SUPPLEMENTAL TESTIMONY OF  
DAVID L. SCHREIBER  
—RANNEY COLLECTOR WATER SUPPLY SYSTEM  
SKAGIT NUCLEAR POWER PROJECT  
DOCKET NOS. 50-522 & 50-523

This testimony supplements the testimony submitted by Drs. Marmer, Zussman and myself in this proceeding on February 17, 1978. It addresses the Licensing Board's concerns relative to (1) the applicants' use of pumping test data (set forth in Appendix G to ER) to predict the yield of the proposed Ranney Collector System and (2) the drawdown effects of the Ranney Collectors on nearby Red Cabin and Muddy Creeks. This testimony also evaluates the effects of the applicants' proposed design changes to the System to meet the mitigation requirements prescribed by the Department of Agriculture in its Wild and Scenic Rivers Act determination of April 11, 1978.

Figure 1 Surface and Groundwater at Skagit Site

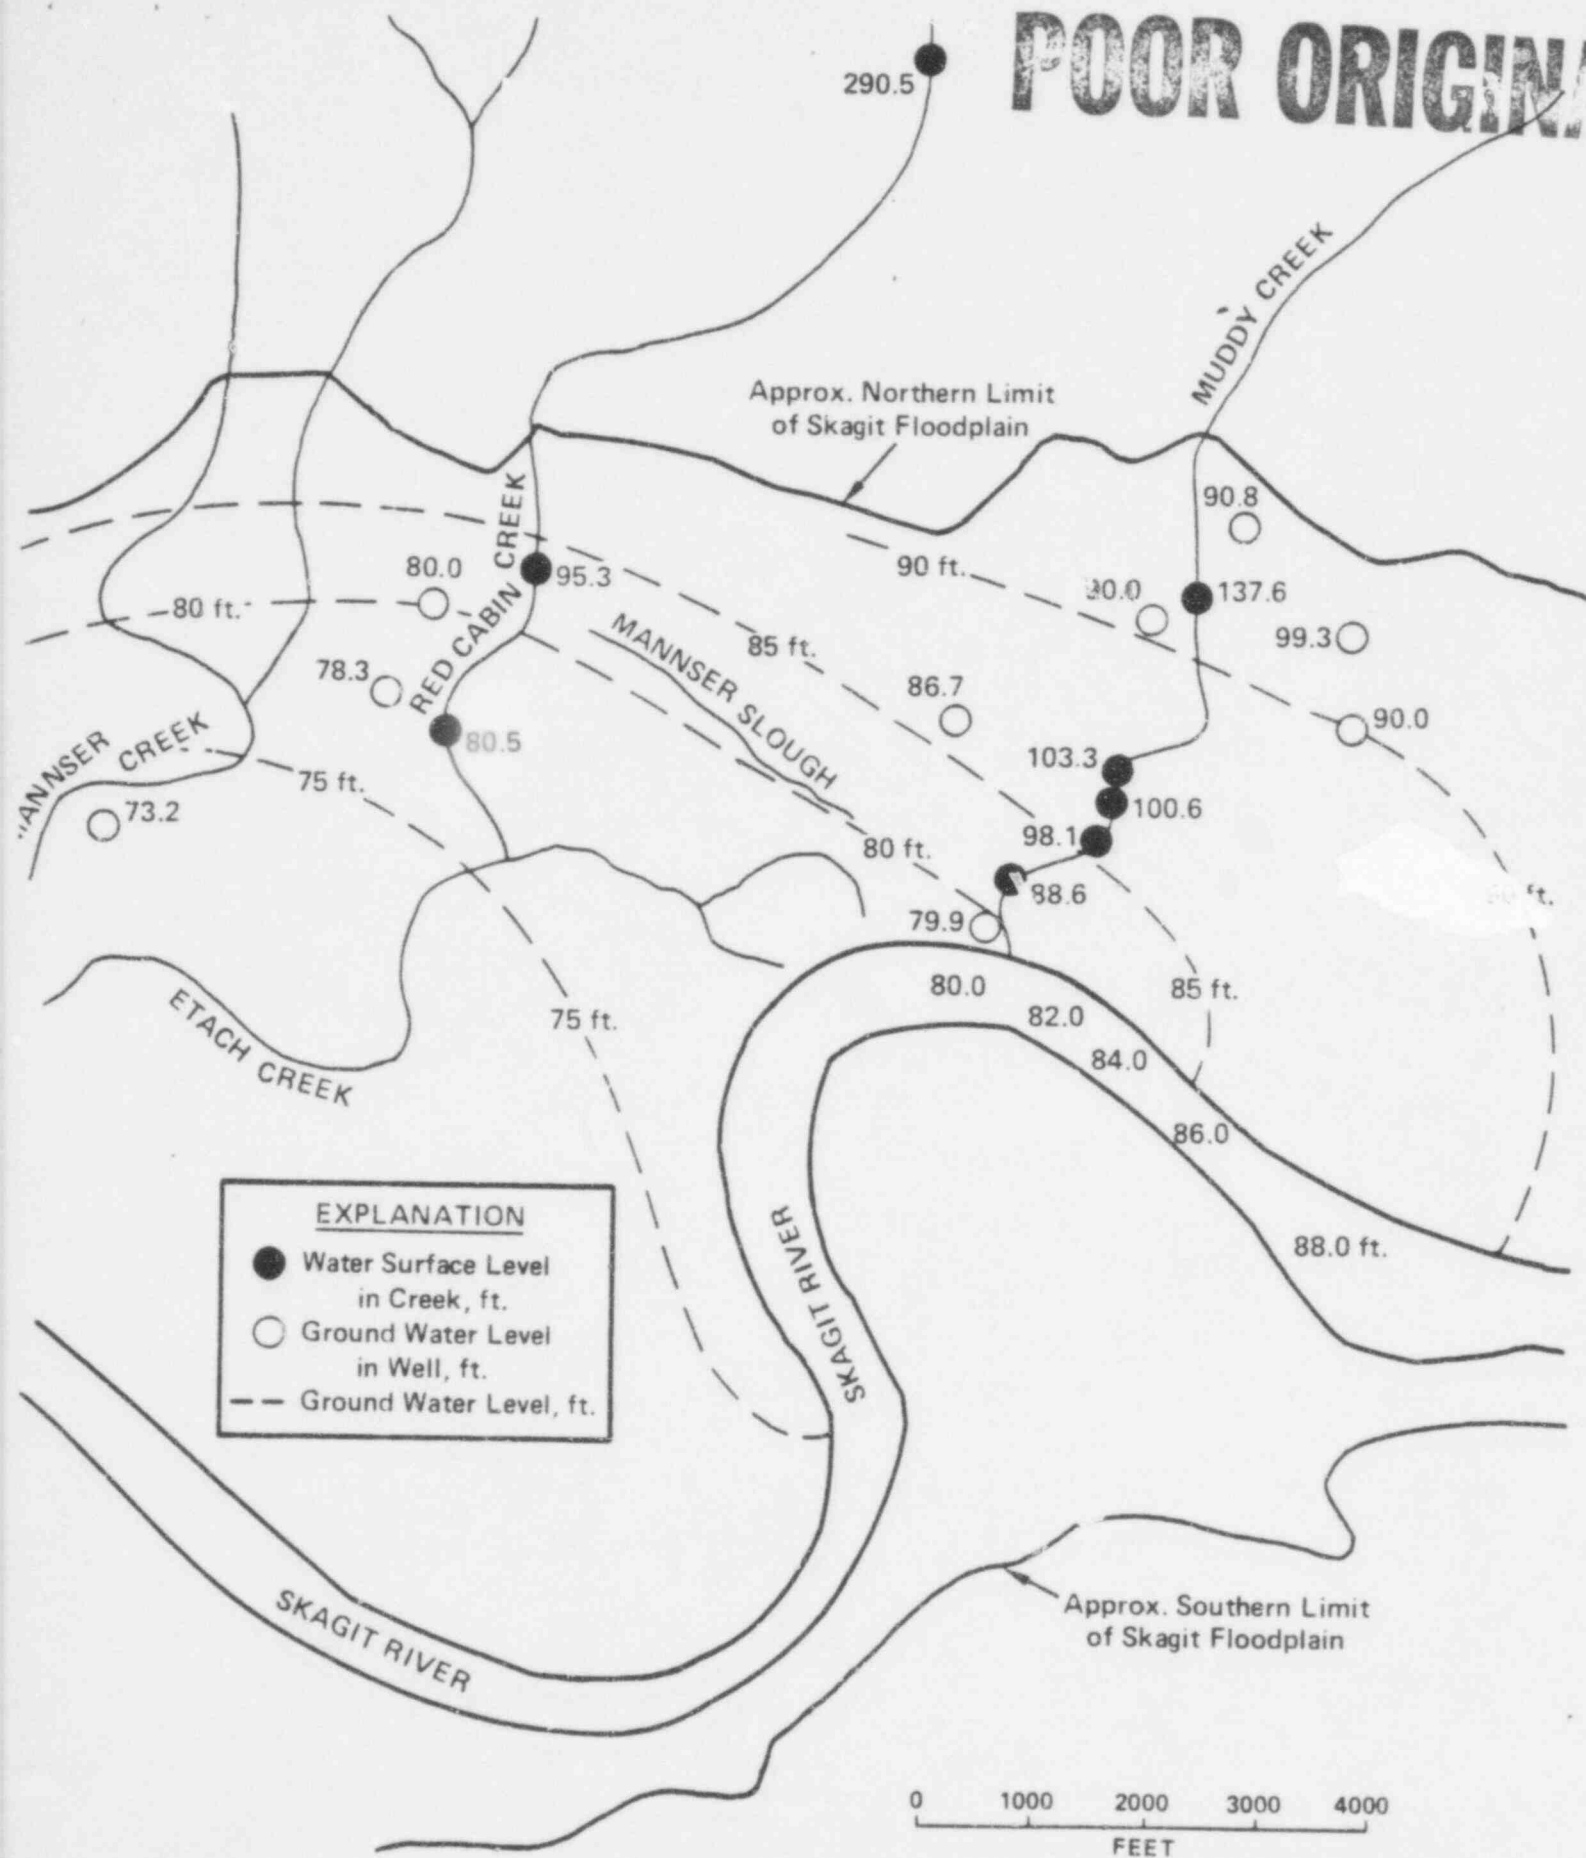
ground-water table elevation contours were sketched on Figure 1 (item 16). Creek bed elevations (Table 3, item 16) were also noted on Figure 1, along with Skagit River water surface elevations (Figure 1, item 9). As evidenced by this Figure, which now includes groundwater table contours, the creek-bed elevations in Red Cabin and Muddy Creeks are everywhere at least several feet above the ground-water table in the Skagit River floodplain. Therefore, the groundwater table drawdown effects of the Ranney Collectors will have no impact on the surface water flowing in either Red Cabin Creek or Muddy Creek.

and debris. The existence of the northern fork of Etach Creek could not be ascertained during the observation period or in aerial photographs (item 17 enclosure). The area where this fork of the creek is depicted on Figure 1 (item 16) did not contain any water, nor were there any indications that water had been there.
